Determination of an Application for an Environmental Permit under the Environmental Permitting (England & Wales) Regulations 2016

Consultation on our decision document recording our decision-making process

The Permit Number is: EPR/FP3335YU
The Applicant is: Gent Fairhead & Co. Limited
The Installation is located at: Rivenhall Airfield
Woodhouse Lane
Kelvedon
Essex
CO5 9DF

Figure 6.1 – Diagram showing the stack height relative to the building height of the proposed Installation and surrounding ground levels (known as Figure 4 in the Applicant’s air dispersion modelling report dated 26 May 2017)

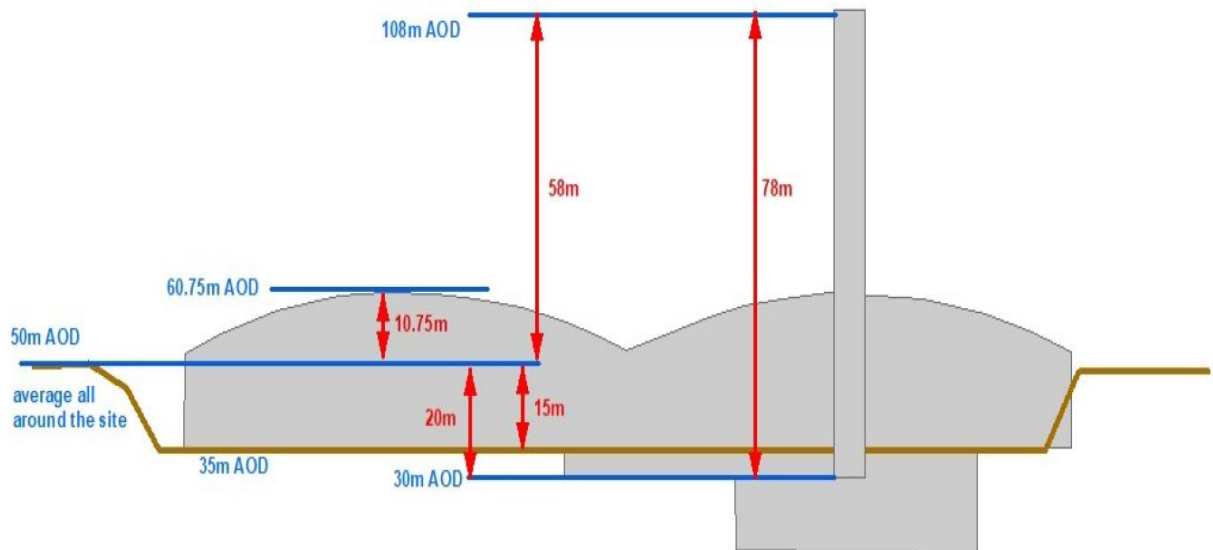
<p>PAIN state that Figure 6.1 in the draft decision document demonstrates that an incinerator of the size of the proposal for Rivenhall should be between 90 and 100 m "above AOD".</p>	<p>We do not understand the term "above AOD" used by PAIN. It is assumed that PAIN refers to 90 and 100 metres above surrounding ground levels. If that is the case, we do not agree with PAIN's statement – the point at which costs begin to outweigh environmental benefits is at 57.4 metres (~ 58 metres) above surrounding ground levels as determined in the cost benefit analysis.</p>	
<p>Rivenhall Integrated Waste Management Facility</p>	<p>Page 191 of 236</p>	<p>EPR/FP3335YU</p>

Figure 6.4 – Applicant’s comparison of total stack height and total building height of 28 energy from waste plants with annual throughputs above 100,000 tonnes. The graph shows the Rivenhall IWMF with a total building height of 30 metres (i.e. 30 metres from the base).

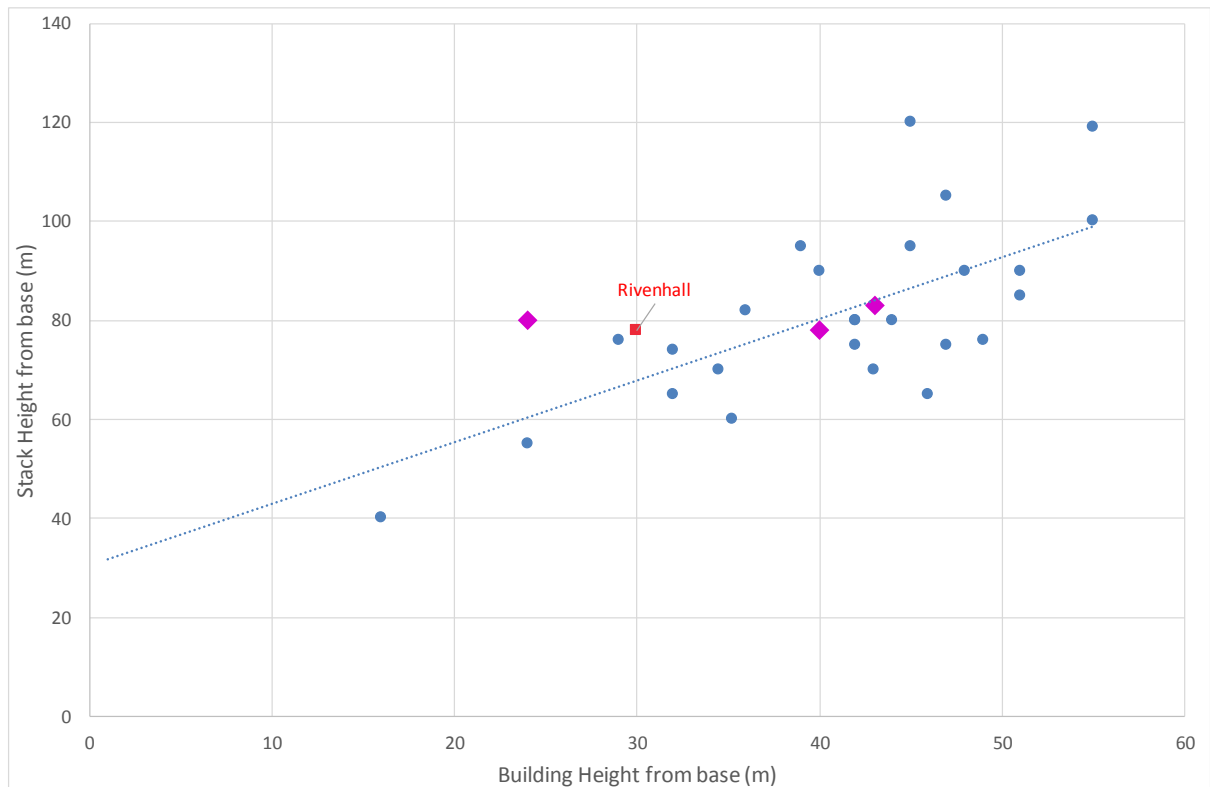
We have examined the data submitted by the Applicant which was used to plot the graphs in this section. We do not agree with the Applicant's statement that there is a clearer relationship between stack height and building height shown in Figures 6.3 and 6.4 than there is between stack height and throughput (Figure 6.2). The line of best fit is a different shape, but the spread of data around the line is roughly the same in all three figures. We have examined the influence of building height on the stack height of a plant in addition to the use of the guidance document D1 in previous permit applications. We agree with the Applicant's statement that the proposed stack height for this Installation is comparable to that of other plants based on the data that has been provided.
